**James City County Environmental Division
Stormwater Management/BMP Record Drawing and
Construction Certification Review Tracking Form**

- Project Name: St. Martins Episcopal Church
County Plan No.: SP-039-00
Stormwater Management Facility: Box Culvert; INFIL BMP (COUNTY TYPE C-4)
BMP Phase #: I II III
 Information Package Received. Date/By: _____
 Completeness Check:
 Record Drawing Date/By: _____
 Construction Certification Date/By: _____
 RD/CC Standard Forms (Required for all BMPs after Feb 1st 2001 Only)
 Insp/Maint Agreement # / Date: _____
 BMP Maintenance Plan Location: _____
 Other: _____
 Standard E&SC Note on Approved Plan Requiring RD/CC or County comment in plan review
 Yes No Location: Pg 8.1 Item 19
 Assign County BMP ID Code #: Code: MC 060
 Preliminary Input/Log into Division's "As-Built Tracking Log"
 Add Location to GIS Map. Obtain basic site information (GPIN, Owner, Address, etc.)
 Preliminary Log into Access Database (BMP ID #, Plan No., GPIN, Project Name, etc.)
 Active Project File Review (correspondence, H&H, design computations, etc.)

Re: St. Martin's Episcopal Church
1333 Jamestown Road, County GPIN 4810100009
County Plan No.: SP-39-00

**SURFACE SHOWING VEGETATION
AND SILT BEFORE DIGGING HOLE "A"**

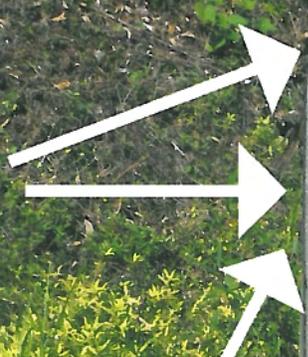
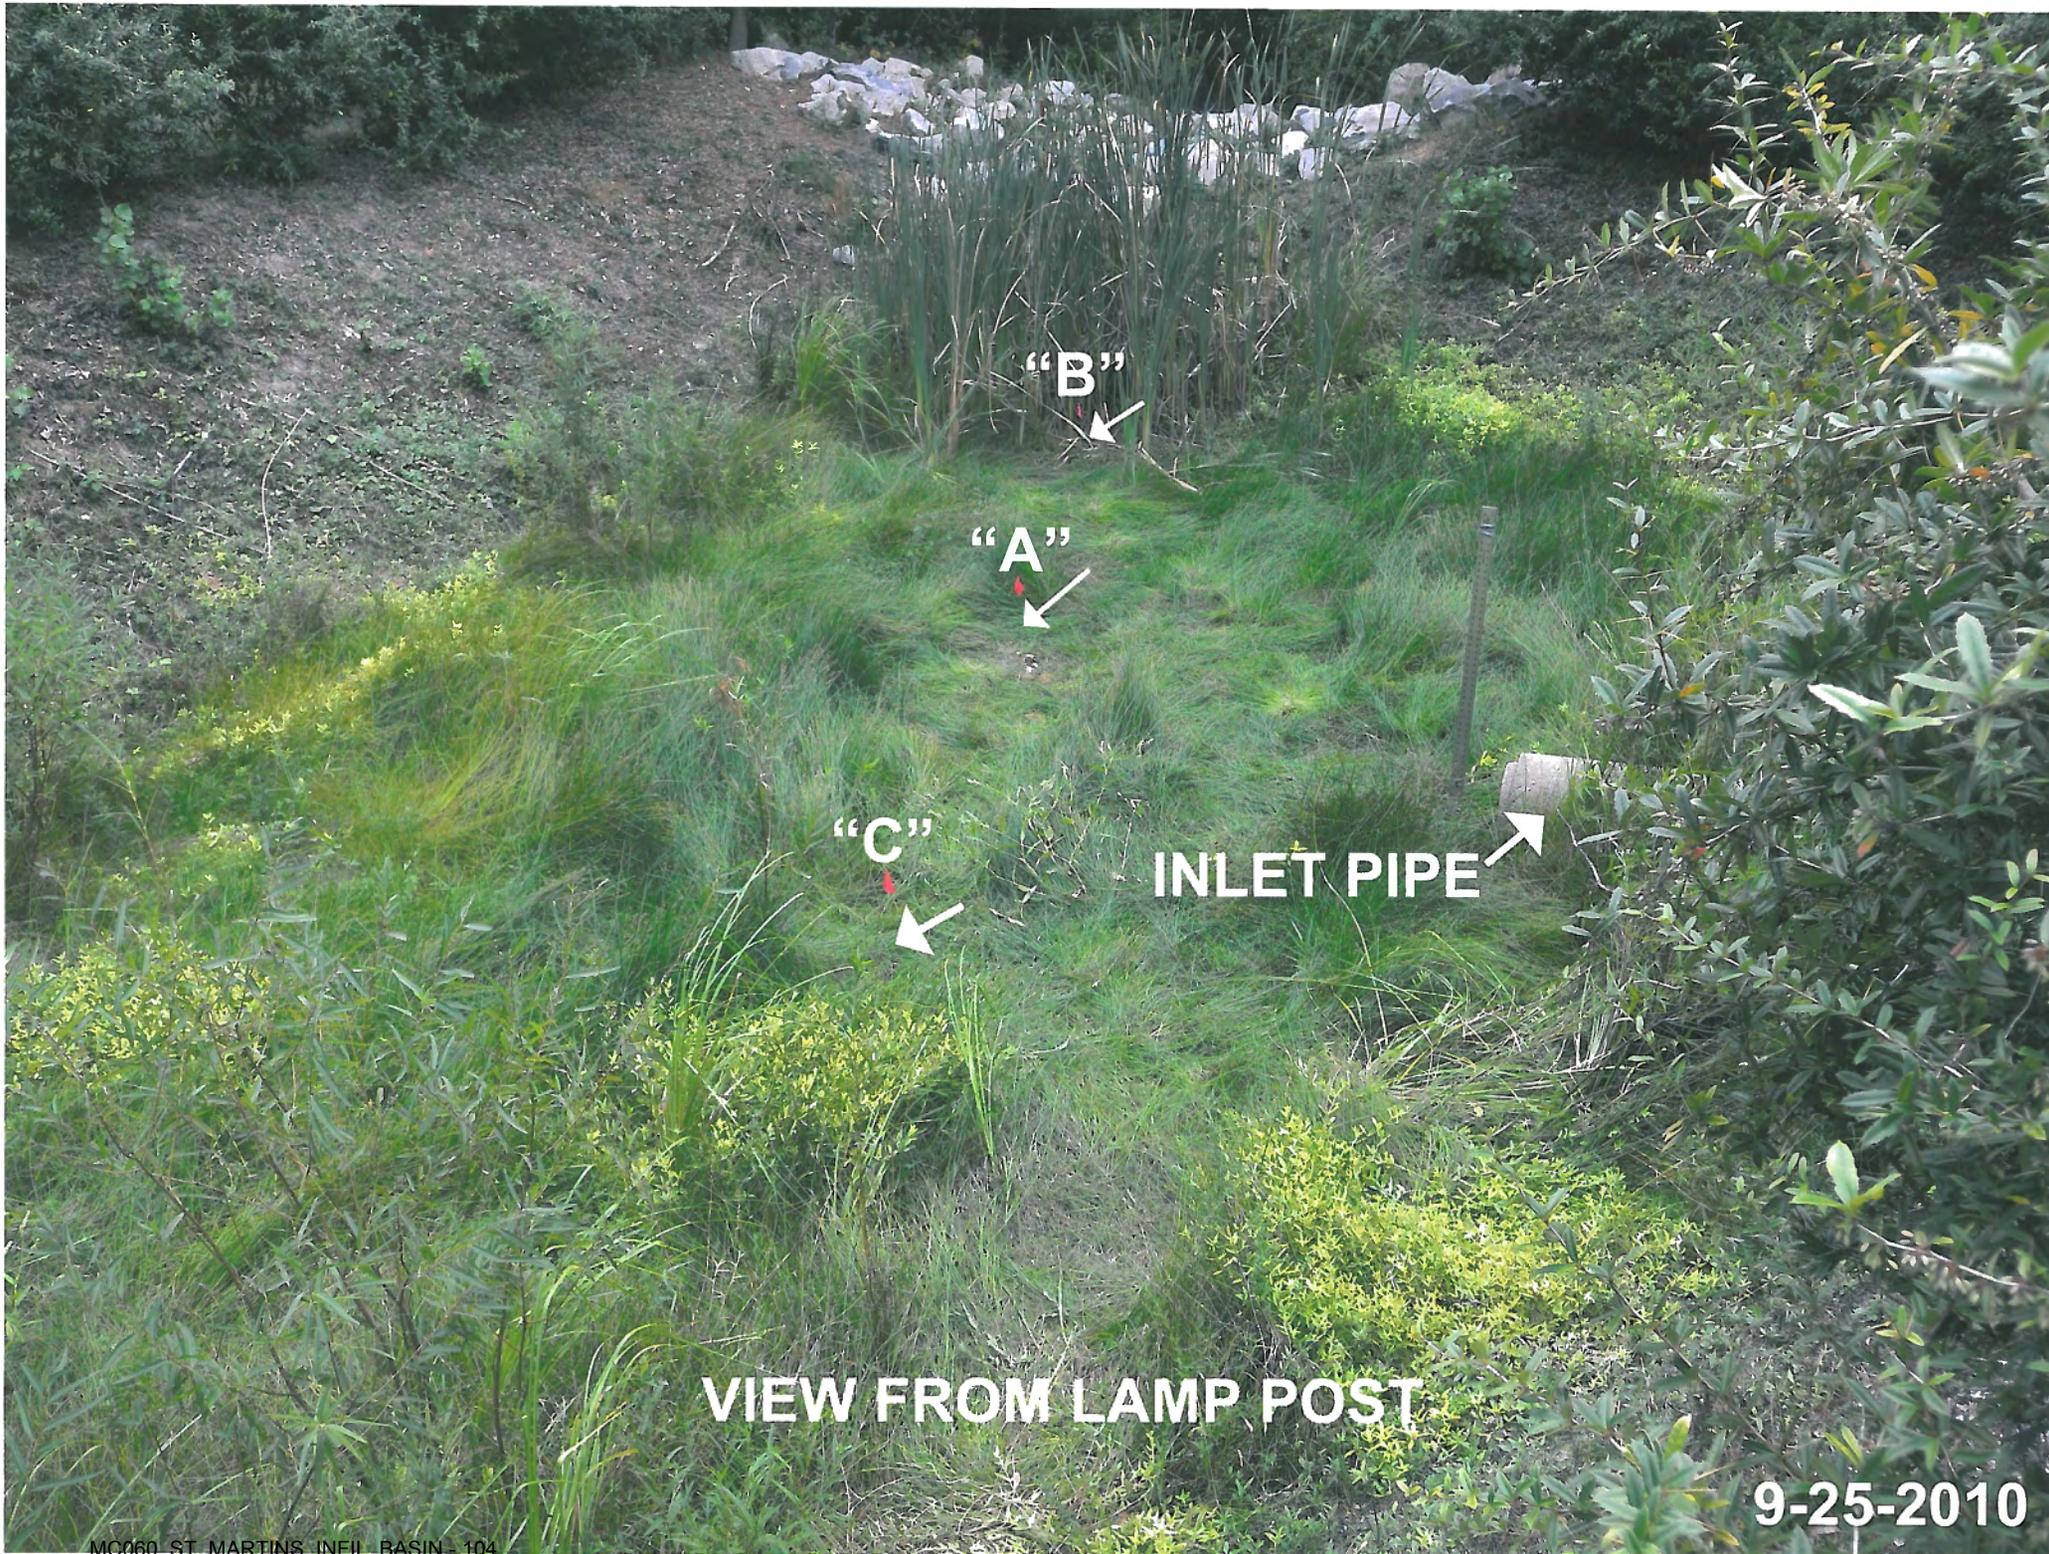
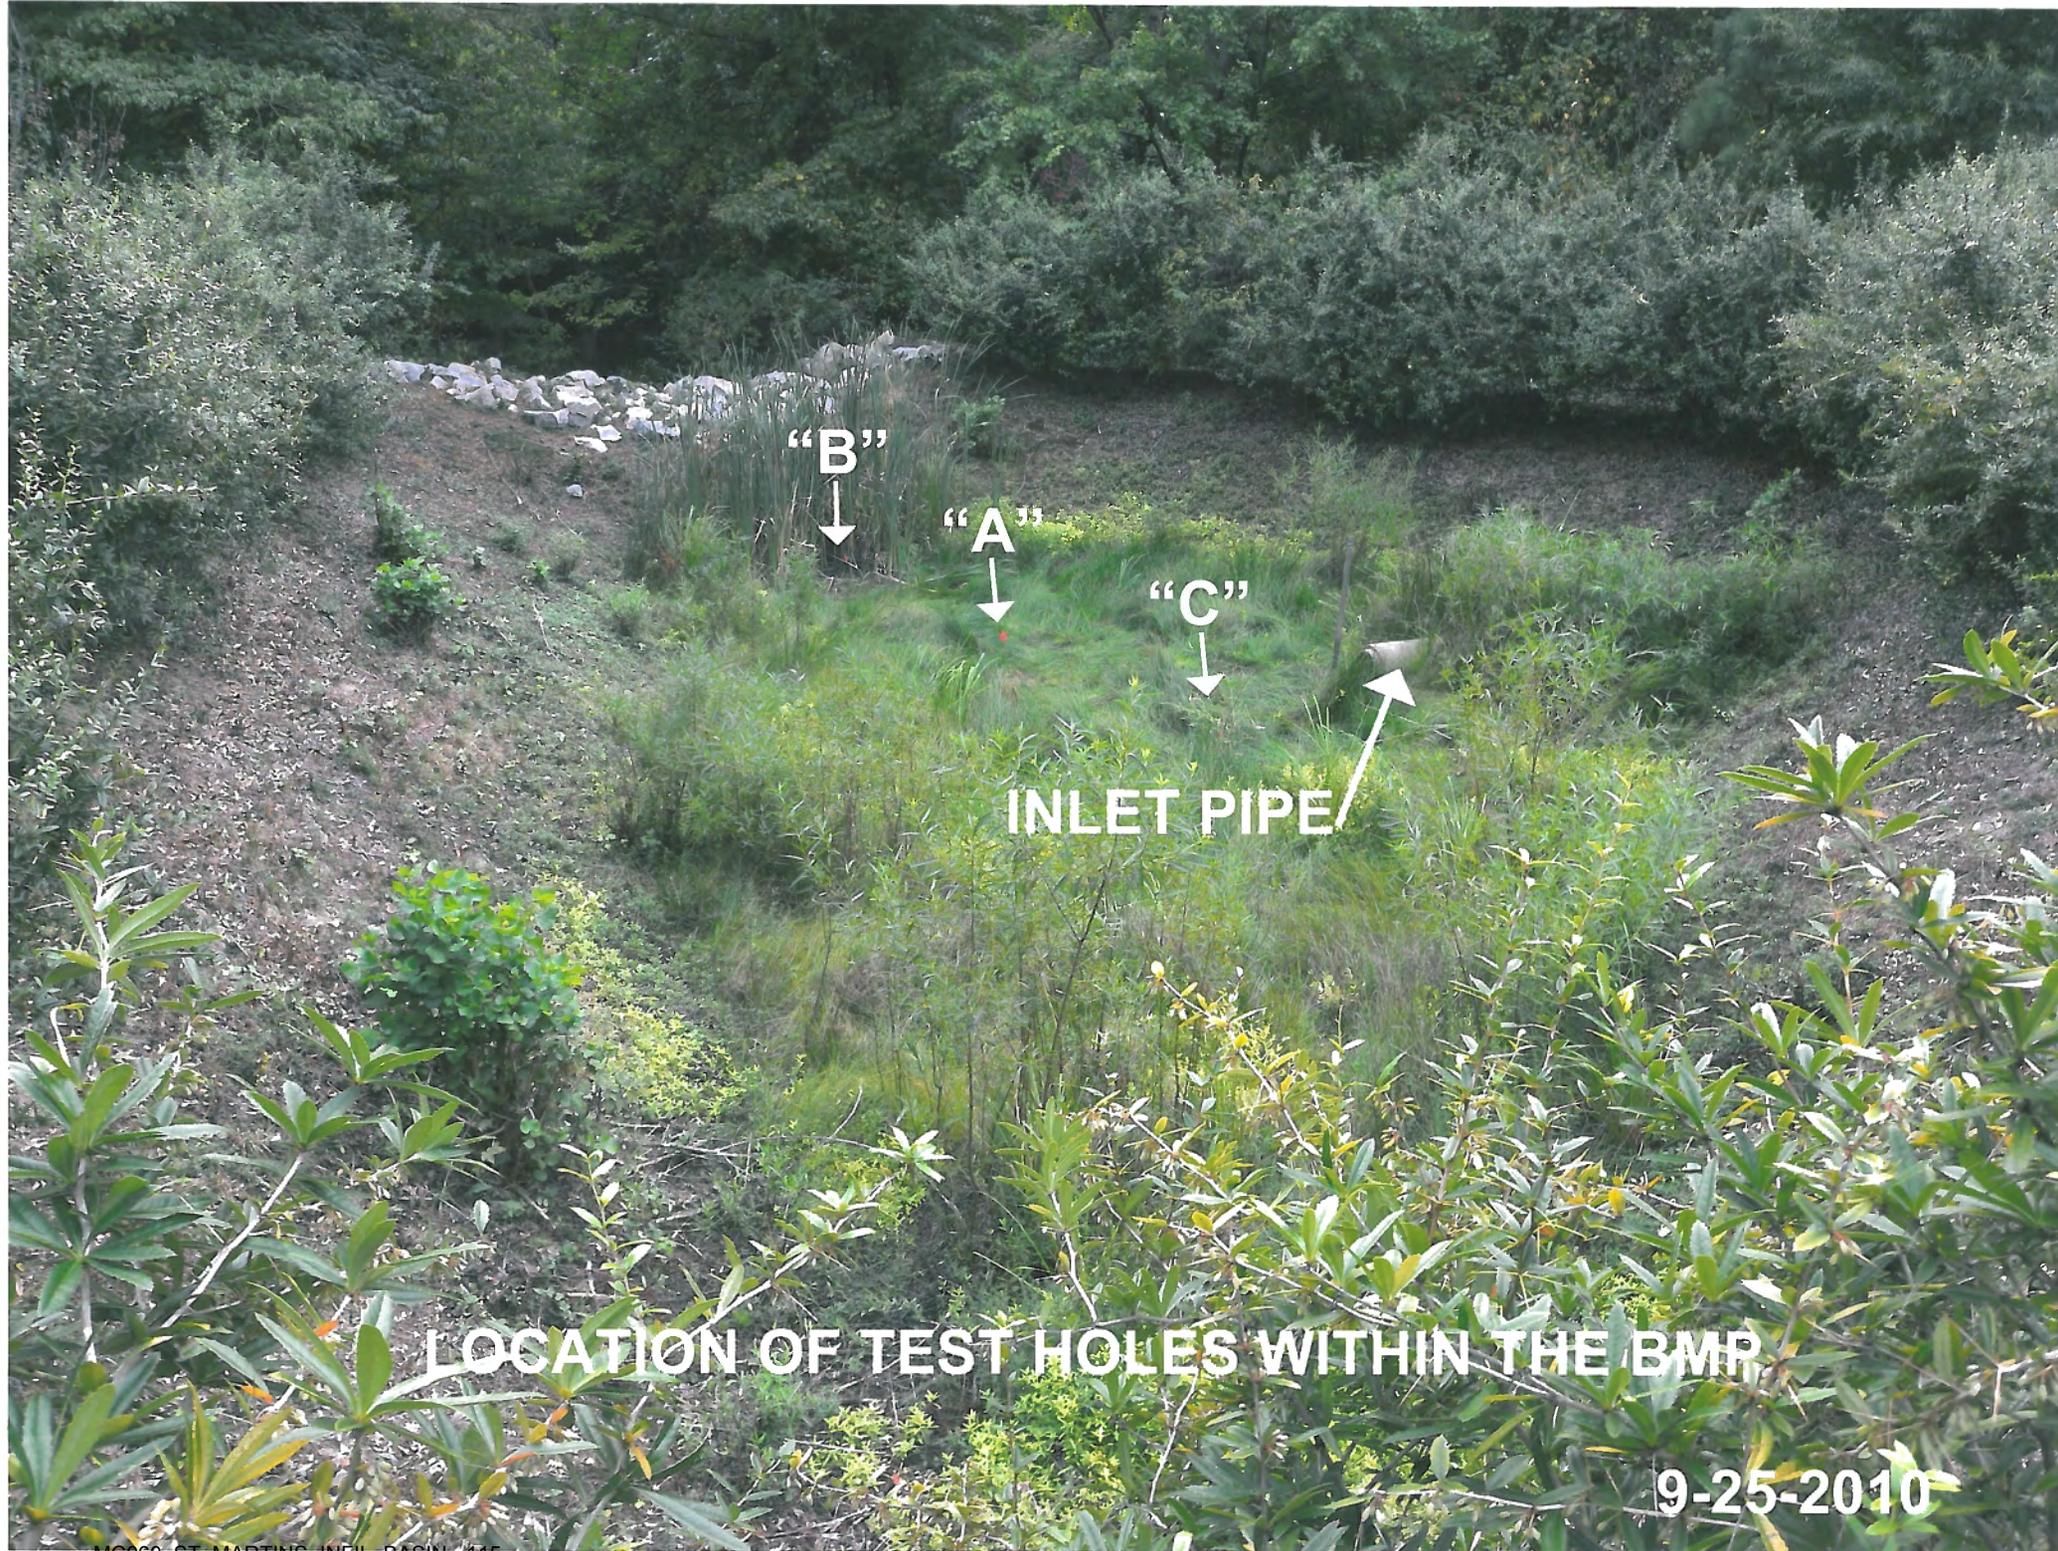
The above will be conditioned on St. Martins investigating the infiltration soils installed within the BMP (infiltration rate, contamination, etc.), and then submit a report to the Stormwater Division with the results. If the soils do not meet the original design criterion, St. Martins agrees to replace the BMP infiltration soils within 3 years following the report.
